**Response to**  
**Request for Additional Information No. 448(4898, 5084)**  
**Supplement 8, Revision 1**

**U.S. EPR Standard Design Certification**  
**AREVA NP Inc.**  
**Docket No. 52-020**  
**SRP Section: 03.08.01 - Concrete Containment**  
**Application Section: 3.8.1**

**Question 03.08.01-51:****Follow-up to RAI 155, Question 3.8.1-22**

**Question 03.08.01-52:****Follow-up to RAI 155, Question 3.8.1-27**

Figure 03.08.01-51-1 and Figure 03.08.01-51-2 show mesh densities of the RCB wall and dome for equivalent and refined slice models.

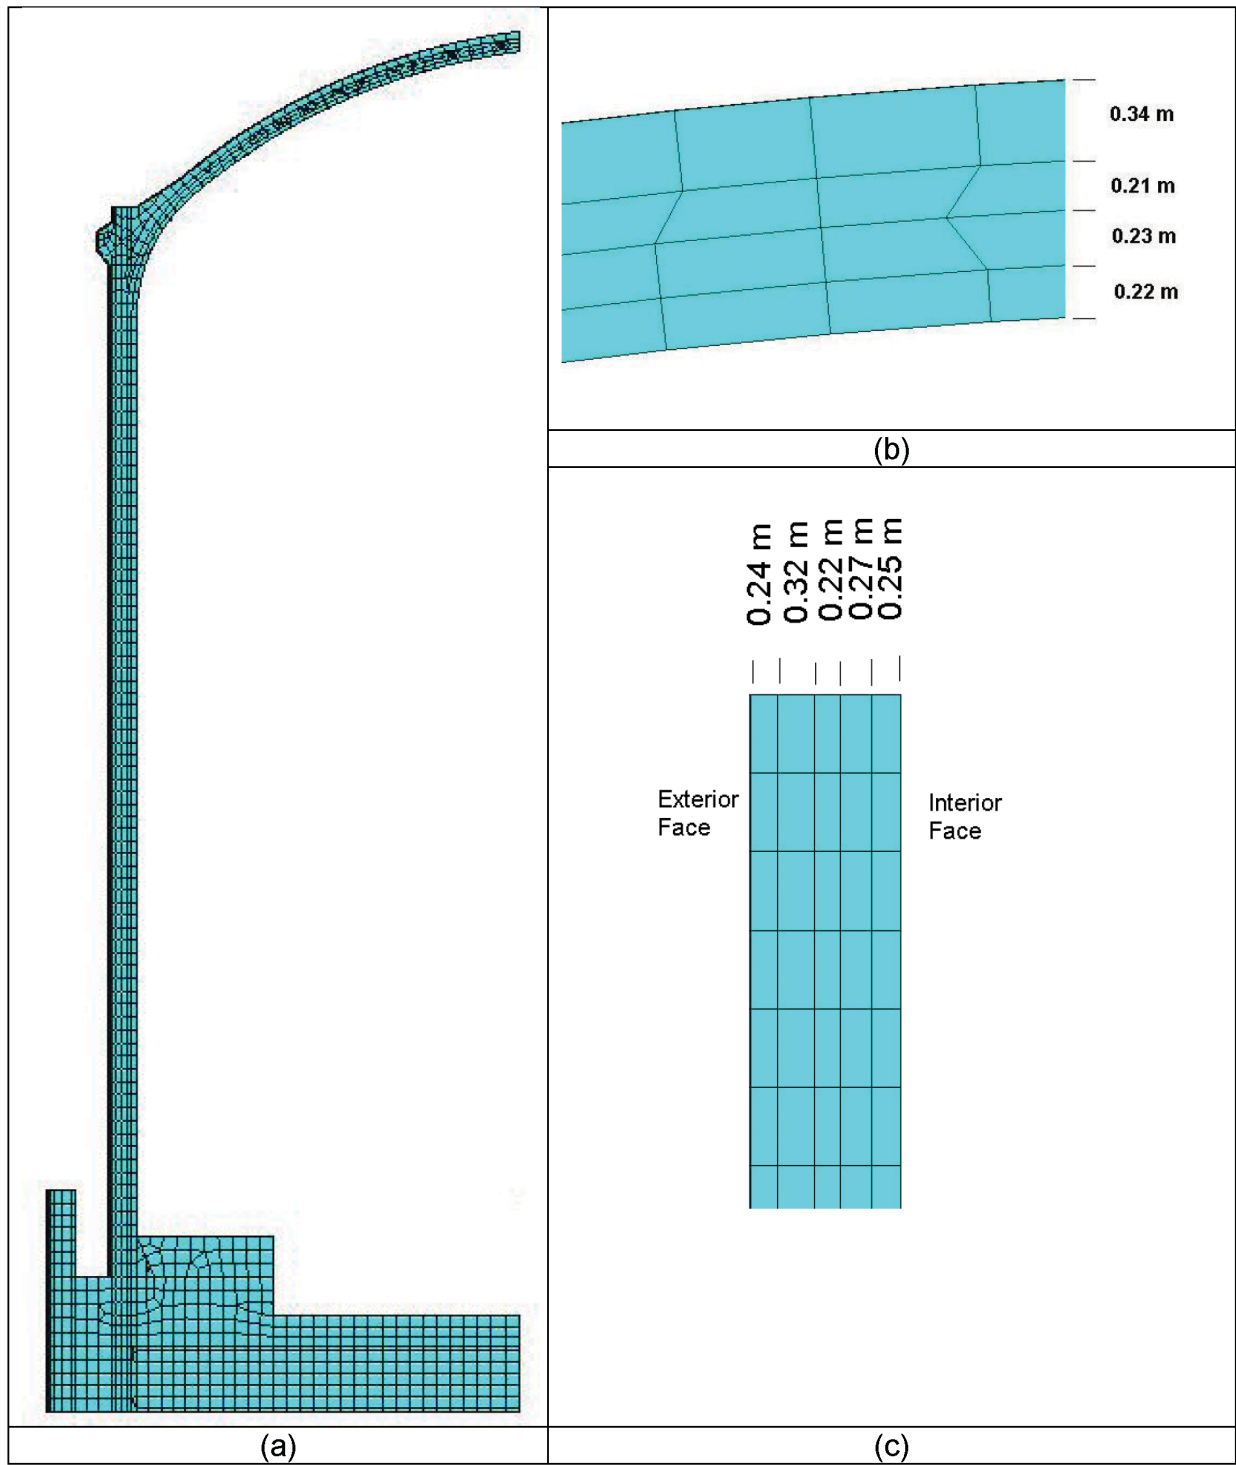
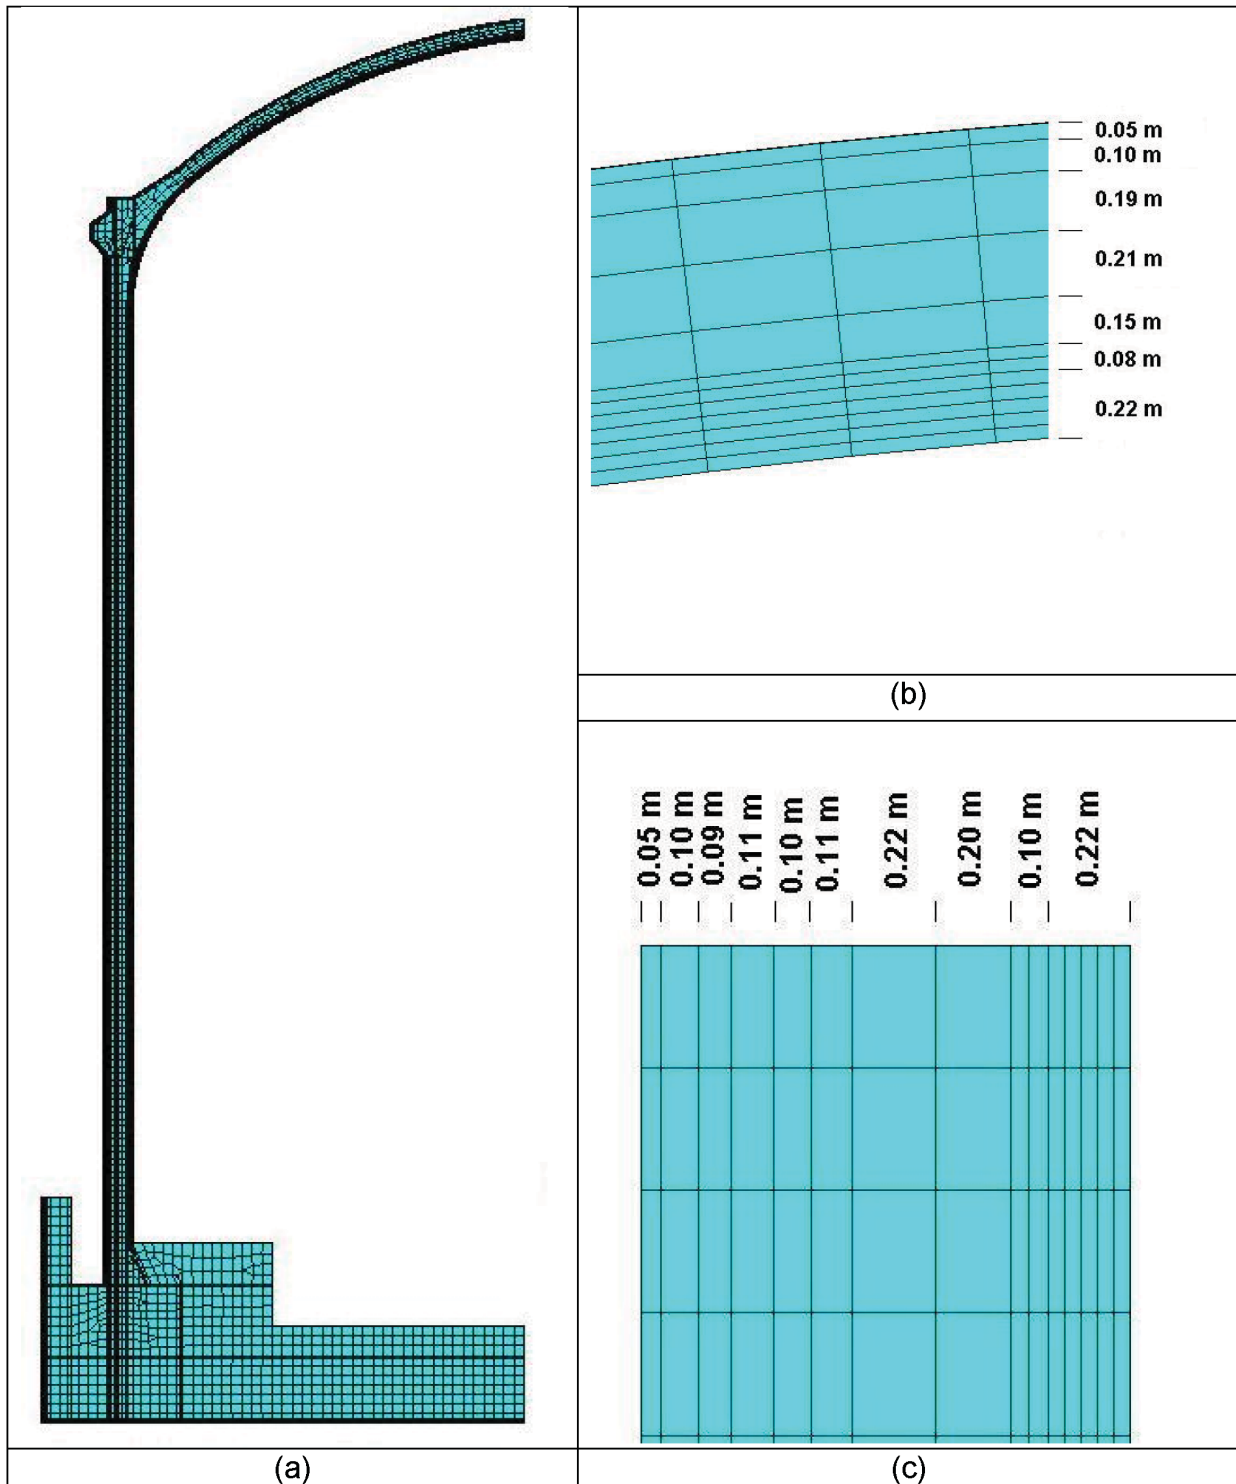
- a. The RAI response states that the mesh density in the 6-degree slice FEM model is increased to calculate the change in thermal moments due to mesh refinement. Provide a description of this mesh refinement, include a figure of each model, and identify the relative sizes of the original vs. the refined mesh.

In response to RAI 03.08.01-22, six-degree slice finite element model (FEM) models were considered with a coarse mesh density and refined mesh density. The slice model with coarse and refined mesh densities are referred to as “equivalent slice model” and “refined slice model,” respectively. The equivalent slice model has similar element thickness and mesh density as the Nuclear Island (NI) static model RCB, and contains five and four elements through thickness of the RCB wall and dome, respectively. The refined slice model has 15 and 12 elements through thickness of the RCB wall and dome, respectively. The equivalent and refined slice models are used for linear structural analysis of the model.

**Figure 03.08.01-52-1—Comparison of Temperature Gradients across the Thickness at Elevation 65.86 ft for (a) Steady State Condition, (b) 1200 Seconds, (c) 1.39 Hours, (d) 24 Hours, (e) 110 Hours, and (f) 1 Year**

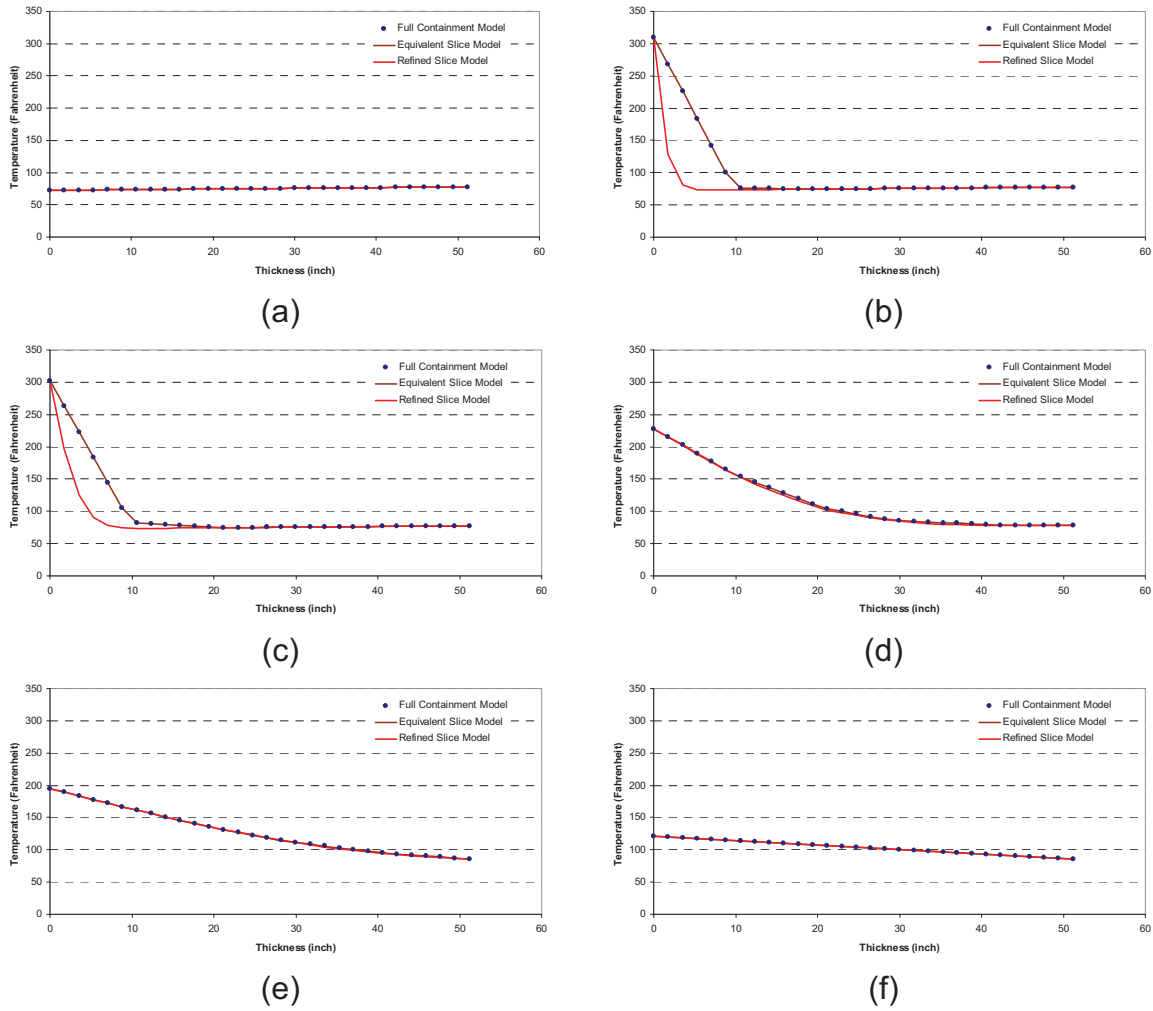
- a. Item 1 of the RAI response indicates that a six degree slice of the containment is studied for mesh refinement in consideration with thermal moment calculations, presumably as described in the response to RAI 3.8.1-22. Based on this study, AREVA indicates that the existing 4/5 element mesh through the thickness of the RCB overestimates the thermal gradient across the thickness, at the beginning of the accident period, and provides an accurate estimate of the thermal gradient at the later period of the accident, compared to the thermal gradient for a refined mesh. To complete the response to Item 1 of the RAI, provide some representative (max., min.) comparison results determined in this study, for selected elements/regions of the RCB, such that the magnitude of the stated conservatism can be quantified. Since the computed thermal moments are subsequently reduced by “thermal moment reduction factors,” as explained in the response to RAI 3.8.1-22, confirm that this conservatism is actually eliminated from the forces/moments used in the RCB design. Information regarding this issue should be provided in conjunction with the response to the follow-up to RAI 3.8.1-22, Items 1 and 2.

Variation in temperatures through the thickness of the containment wall (at 65.86 feet) and dome (75 degrees from horizontal) at different time points for the equivalent slice model and refined slice models are shown in Figures 03.08.01-52-1 and 03.08.01-52-2.

Thermal moments from linear analysis at the containment wall (at 65.86 feet) and dome (75 degrees from horizontal) sections for the equivalent slice model and refined slice model are shown in Table 03.08.01-52-1 and Table 03.08.01-52-2, respectively. Thermal moments from the refined model are significantly reduced at the beginning of the accident time period because

Figure 3.8-20—Accident Temperature versus Time (Reactor Containment Building)

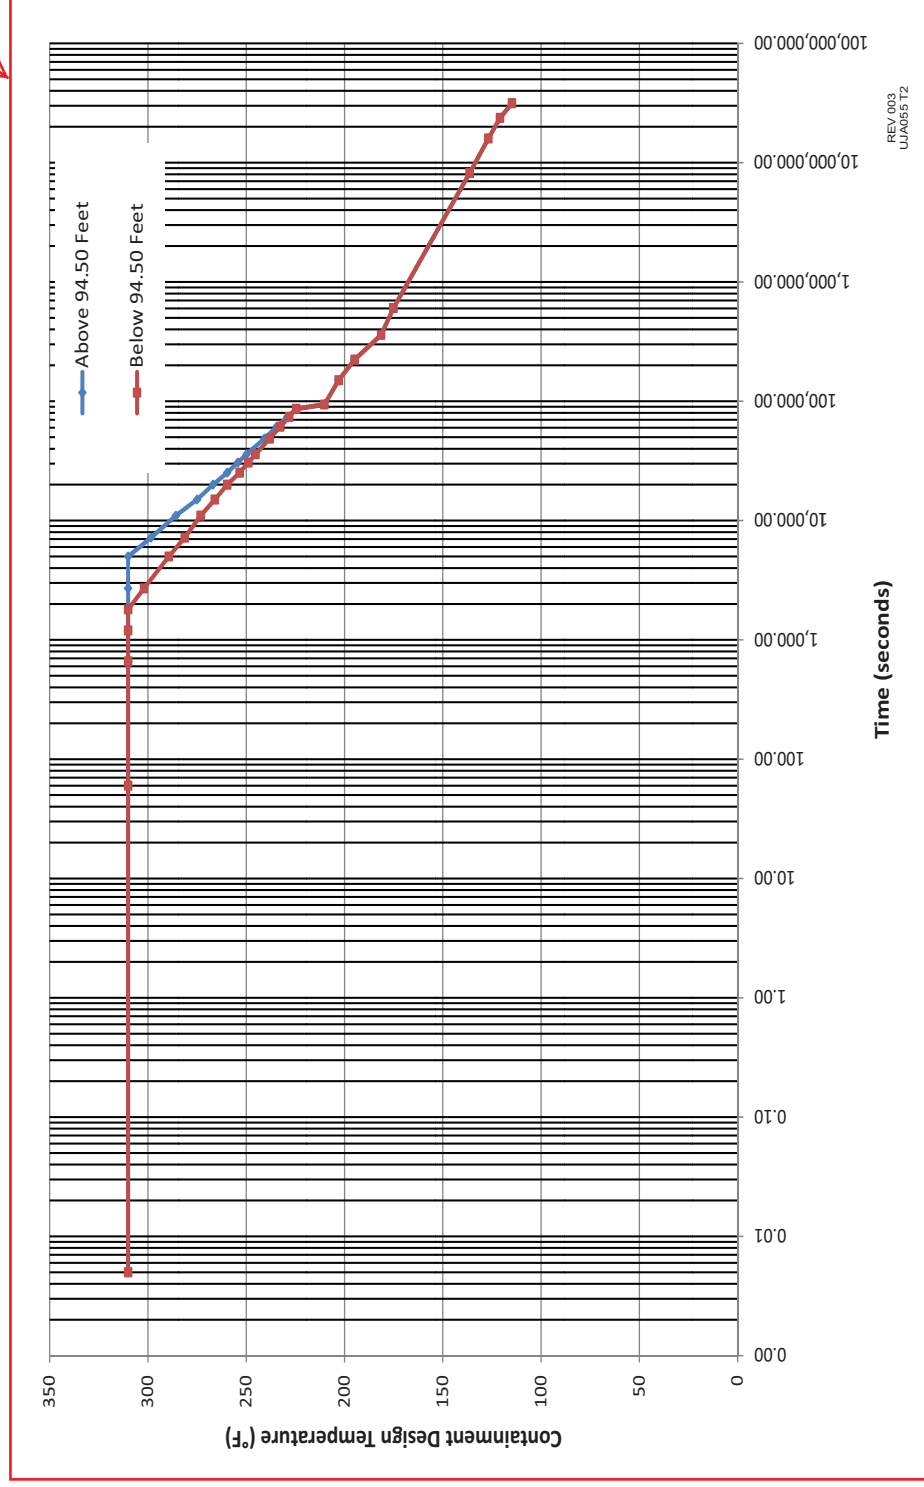
- f. Explain how the thermal loads are applied to the nonlinear FEM model. The RAI response simply states that “the model is subjected to accidental pressure loads,” or “the model is subjected to accidental temperature and pressure loads.” However, it is not clear whether the analysis considered the variation of the temperature gradient across the containment thickness at the four critical time points identified in the temperature and

U.S. EPR FSAR Tier 2, Section 3.8.1.4.5, Figure 3.8-20 and 3.8-21 will be revised as described in the response and indicated on the enclosed markup.

03.08.01-51
